Interference Between Refrigerant Line and Front Engine PTO (FEPTO)

M-870-001

(November 2007)

All Mack MRU models with a FEPPTO built before July 23,2007

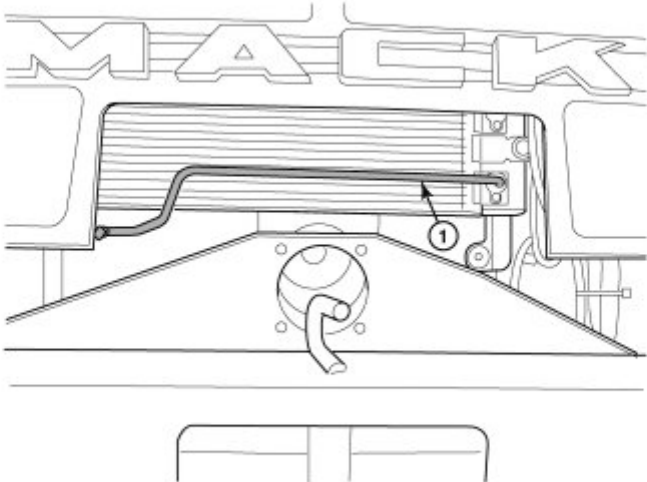
On MRU model chassis manufactured prior to July 23, 2007, and equipped with front engine power take-off (FEPTO), an interference condition exists between the air conditioning refrigerant line and the FEPTO drive shaft. To eliminate this condition, a revised refrigerant line (part number 212RD4111M) is available through the MACK Parts System. The revised refrigerant line is routed above the FEPTO opening in the radiator, thus eliminating any interference with the drive shaft.
